WOLF CREEK NUCLEAR OPERATING CORPORATION

August 13, 2013
ET 13-0023

Subject: Docket No. 50-482: License Amendment Request for the Transition to Westinghouse Core Design and Safety Analysis

Trip Setpoints and Allowable Values

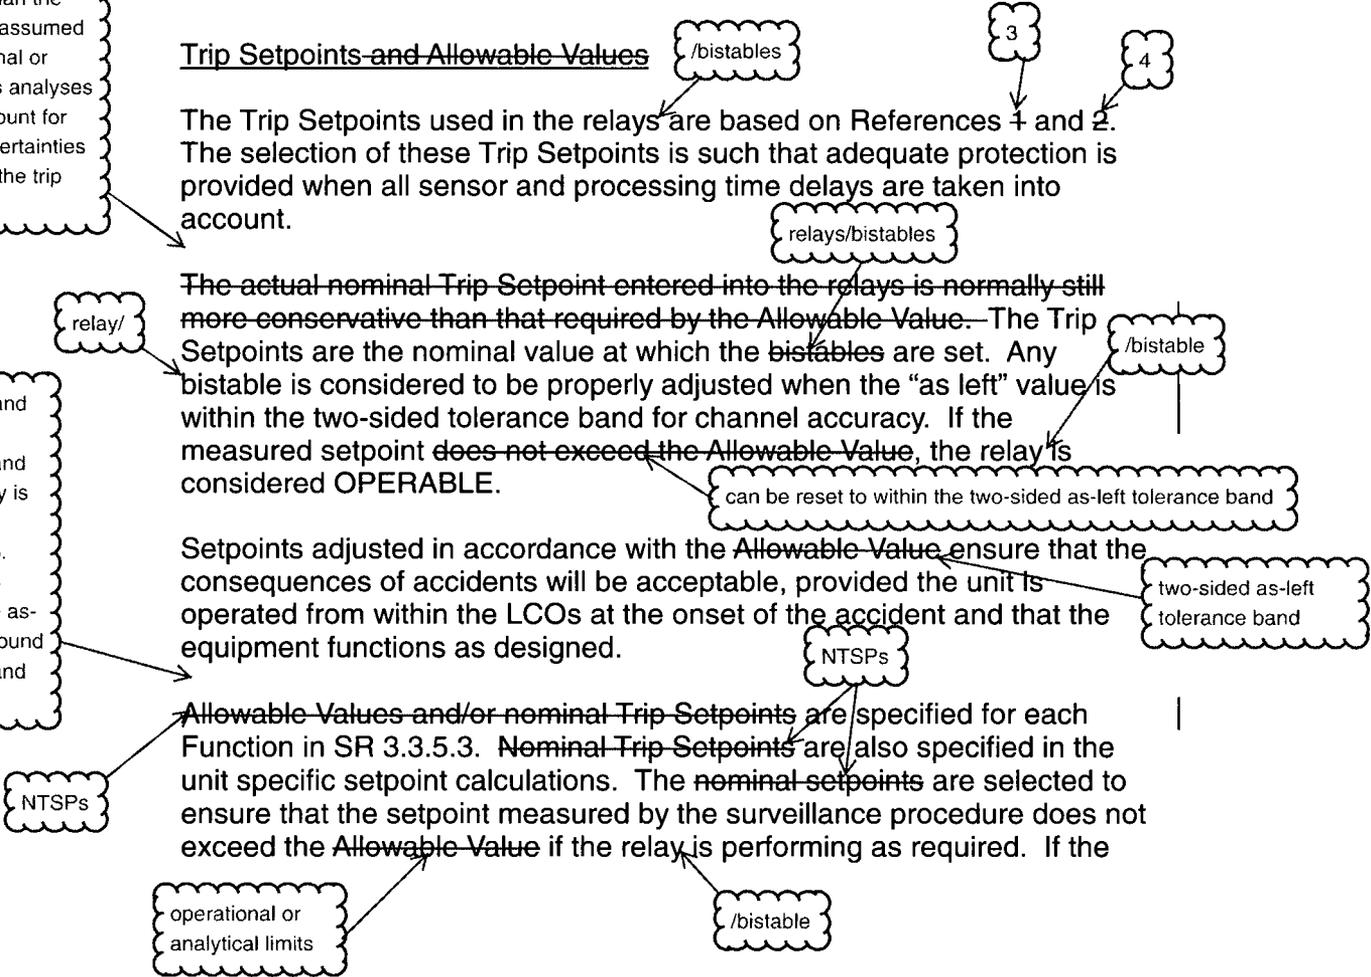
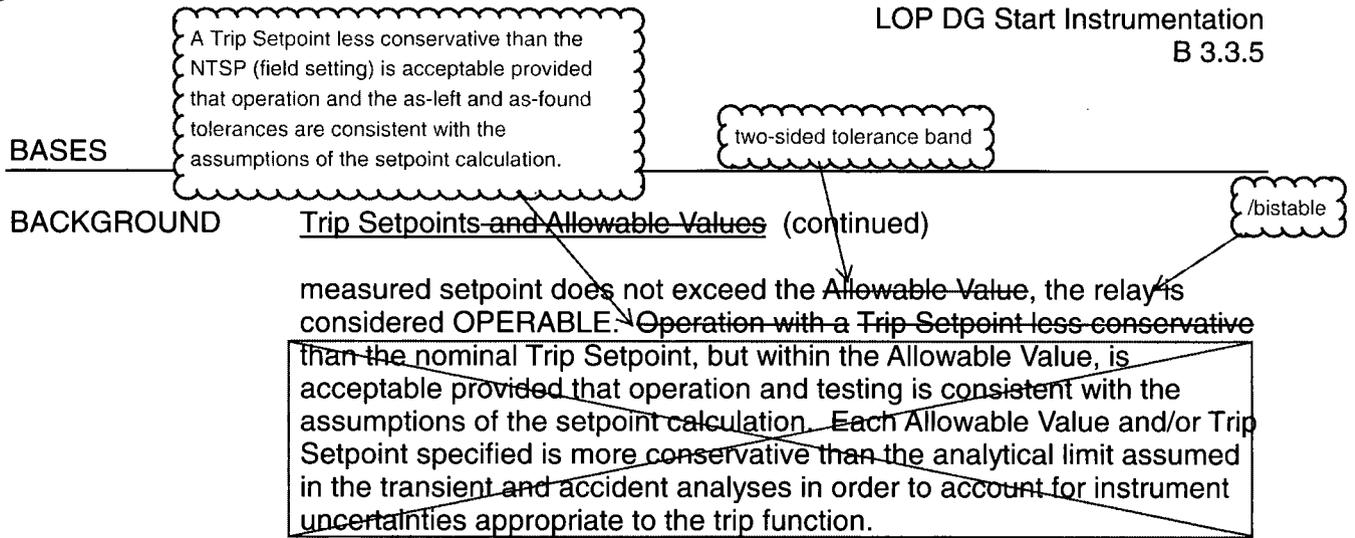
The Trip Setpoints used in the relays are based on References 1 and 2. The selection of these Trip Setpoints is such that adequate protection is provided when all sensor and processing time delays are taken into account.

The actual nominal Trip Setpoint entered into the relays is normally still more conservative than that required by the Allowable Value. The Trip Setpoints are the nominal value at which the bistables are set. Any bistable is considered to be properly adjusted when the "as left" value is within the two-sided tolerance band for channel accuracy. If the measured setpoint does not exceed the Allowable Value, the relay is considered OPERABLE.

Figure 2.1
Reactor Core Safety Limits

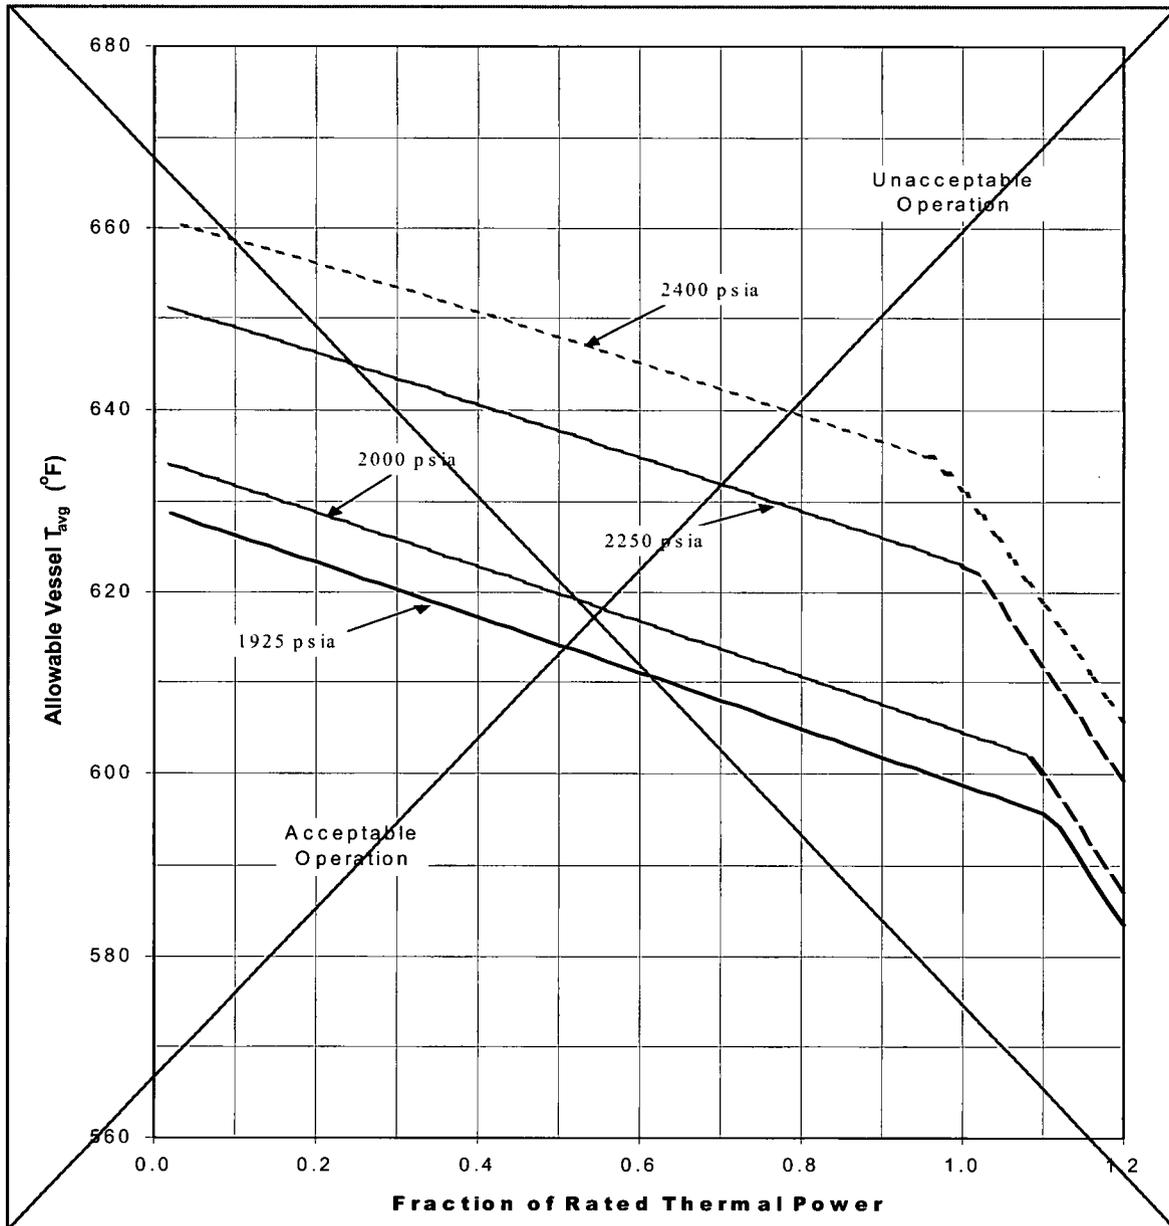
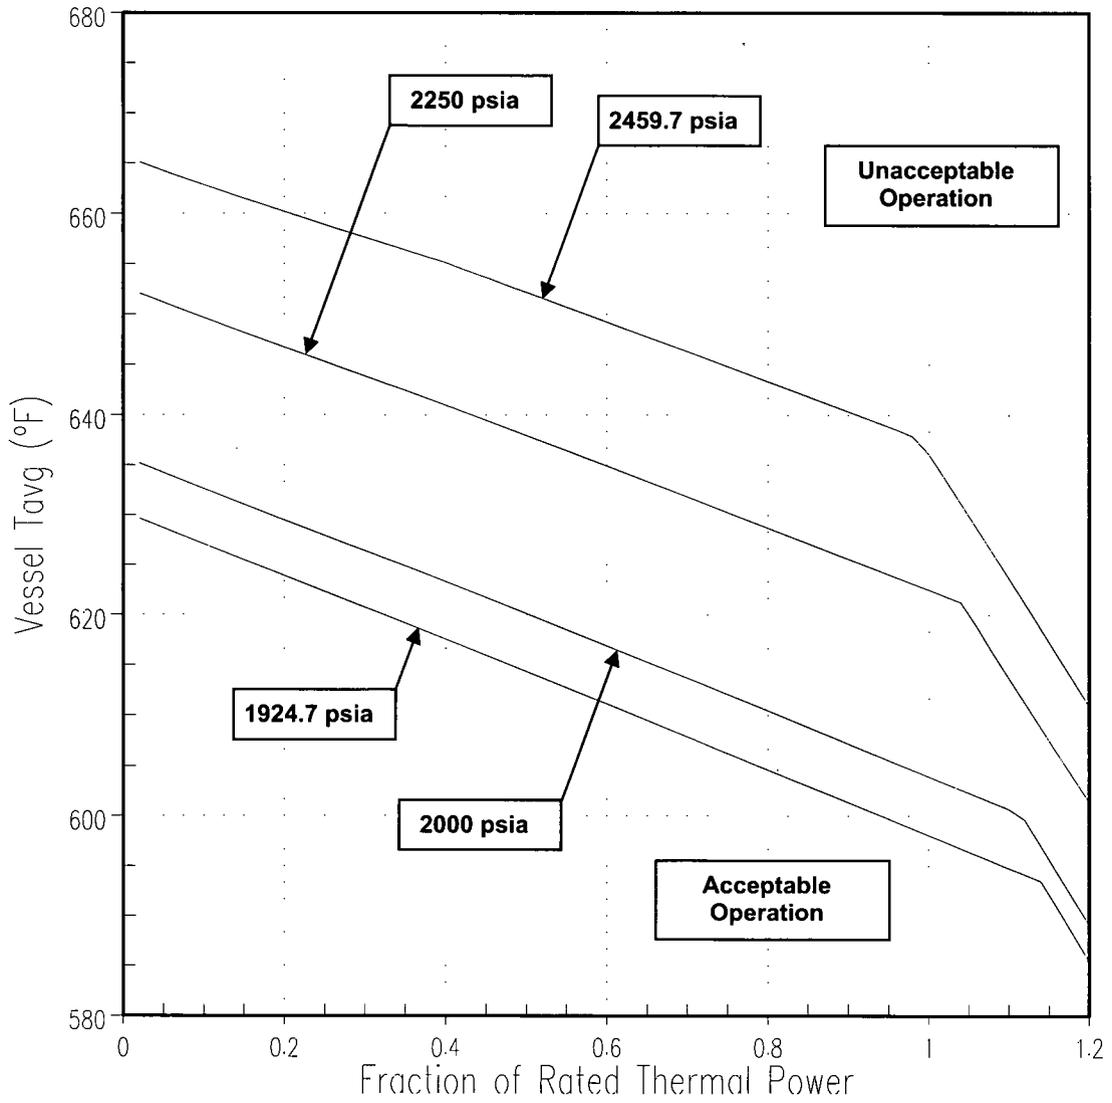
2.1 Reactor Core Safety Limits (SL 2.1.1)

In MODES 1 and 2, the combination of THERMAL POWER, Reactor Coolant System (RCS) highest loop average temperature, and pressurizer pressure shall not exceed the limits in Figure 2.1.
